Bombay Commercial Vehicle Safety Centre – Response to Section 92 RMA Request for Further Information

BUN60424934 – Notice of Requirement and resource consents for the Bombay Commercial Vehicle Safety Centre – S92 Responses to Auckland Council

Figure 1 Key Performance Indicators

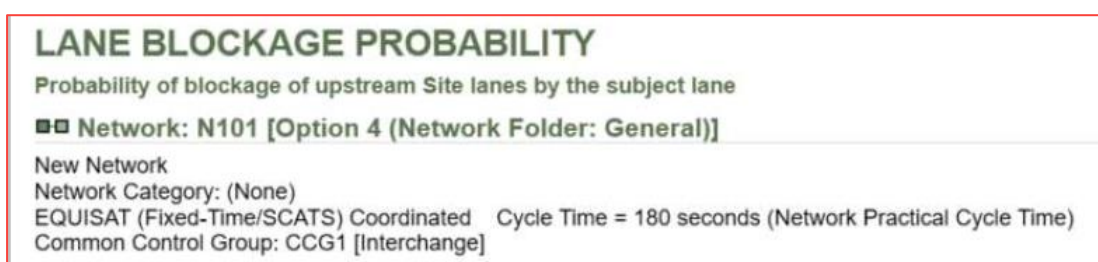
RFI 17. Traffic Modelling. Provide evidence to demonstrate that 3 minutes is an appropriate measure for the maximum time for motorists to wait before entering the intersection.

Key performance indicators for evaluating the intersection's performance encompass the Level of Service (LOS), Degree of Saturation (DoS) and Average Delay. In the modelling analysis, refer to Figure 1 below, the cycle time of 180 seconds was set up in the signalised intersection models as a network practical cycle time. The mentioned 3 minutes in the report serves as an illustrative example of network cycle time rather than a decisive trigger indicator.

Figure 2 – CVSC Site manoeuvres

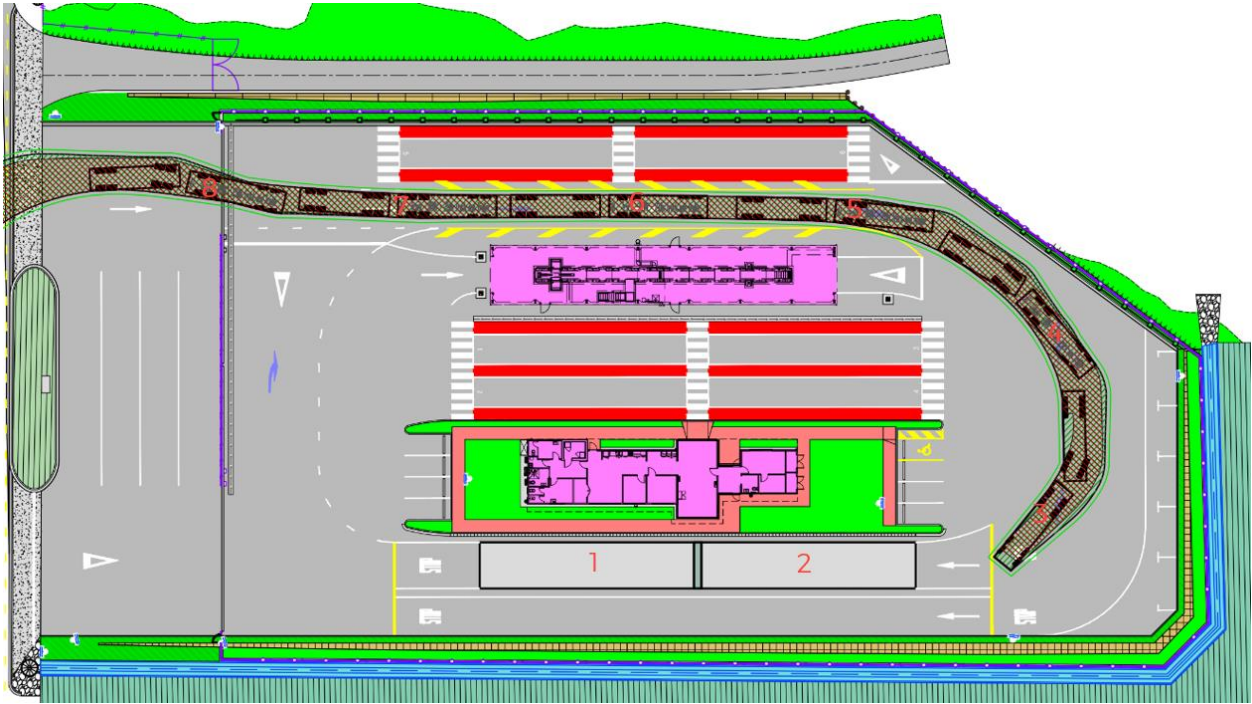
RFI 29. Site Operation. Provide details of how oversized vehicles will be managed when there are already trucks in the inspection bays to prevent trucks from queuing back into the adjacent road reserve.

The initial step in the truck inspection process involves proceeding to the weigh bridge and subsequently navigating to various bays under the guidance of staff. As illustrated in Figure 2 below, the CVSC has capacity to simultaneously accommodate a maximum of eight trucks with trailers, each extending up to 23 meters in length, including two vehicles on the weigh bridge. As outlined in RFI 12 regarding trip generation, during the peak hour, a maximum of 17 vehicles will visit the CVSC at different intervals, a capacity that can be effectively managed on-site.

The oversized vehicles will also be required to operate with a permit. Therefore, the police and NZTA will know about these oversized vehicles in advance. It is unlikely that a vehicle of that size (10m wide) will be on the road during atypical hours of operation for this site because they usually drive overnight.

Regarding the inspection bays, the bays at the top of the site are likely to be used last. They are there for peak times but will not likely be used as the primary option because they require a circular manoeuvre around the site to enter. It is highly unlikely that a vehicle 10m wide would be on the site at the same time these inspection bays are in use. If this were to happen then the vehicles in the northern inspection bays would have to move to the offload area and allow the oversized vehicle to manoeuvre through the site (and potentially occupy more than one inspection bay). The drivers will be with their trucks during the inspection process and thus will be able to move their trucks quickly upon request.

Figure 3 - Typical cross-section of the timber retaining wall showing proximity to the delineated wetland extent (refer to Drawing Sheet C-3010)

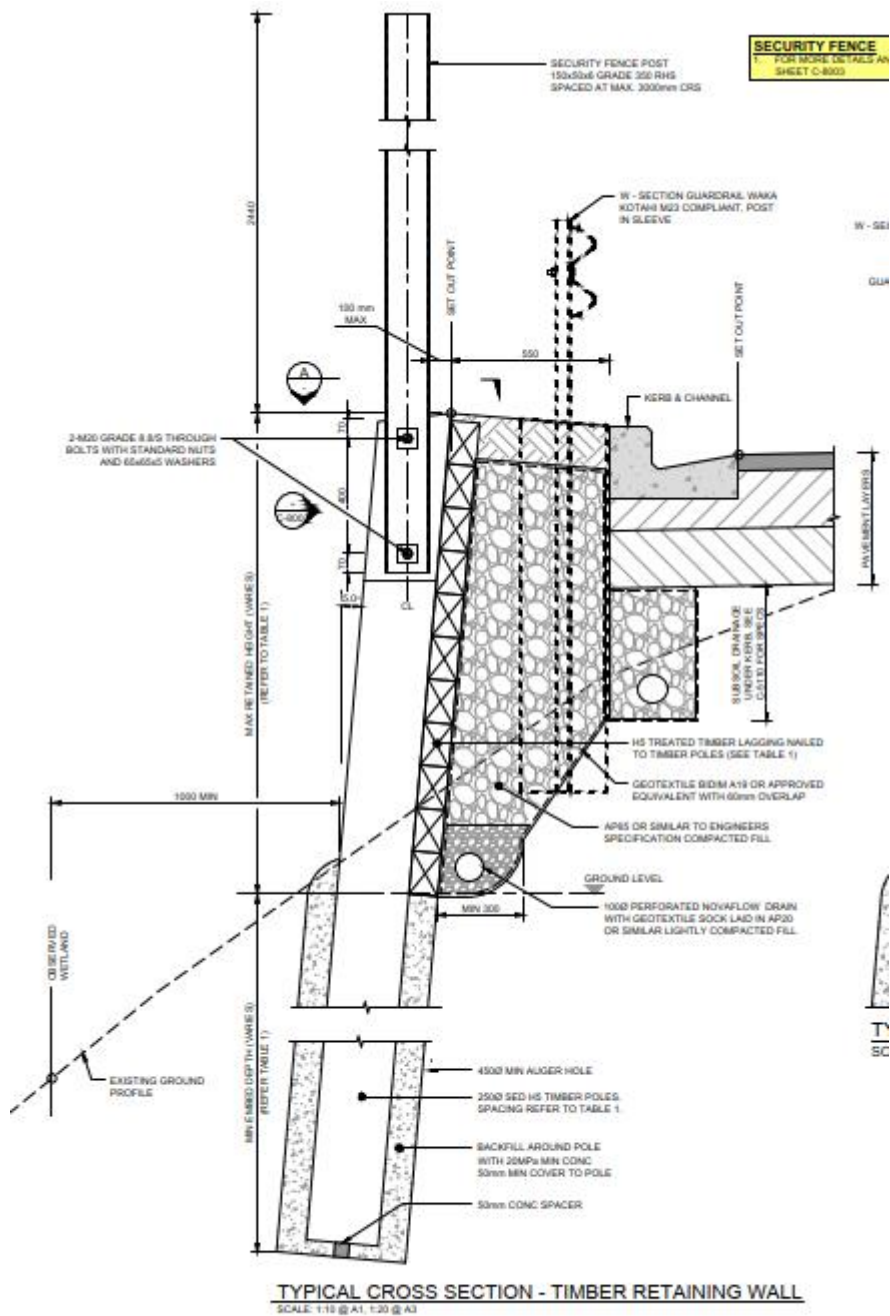
RFI 62. The AEE indicates that consent is required for E3.4.1 (A44) Any activities not complying with the general permitted activity standards in E3.6.1.1 or the specific activity standards in E3.6.1.14 to E3.6.1.23. Please discuss what activities trigger the need for this consent and clearly indicate the location of this activity on a plan.

Temporary diversion and damming of surface water may be necessary in proximity to the wetland area during construction. The proposed methodology could entail sheet piling during earthworks with necessary rigorous erosion and sediment controls as per the final Erosion and Sediment Control Plan. This will protect the temporary cut slope on the north-eastern boundaries adjoining the wetland until building the permanent retaining walls. As shown in Figure 3 (C-3010) provided in **Appendix 18**, the proposed construction method will be implemented within a restricted space of approximately 900mm between the wetland perimeter and the base of the permanent retaining wall.

In the absence of detailed construction methodology, it is anticipated there will be temporary structures (E3.6.1.15) at the interface between the retaining wall and the wetland on the north-east corner of the site. Under E3.6.1.15 the temporary structure must not be in place longer than 14 days within any 6mth period.
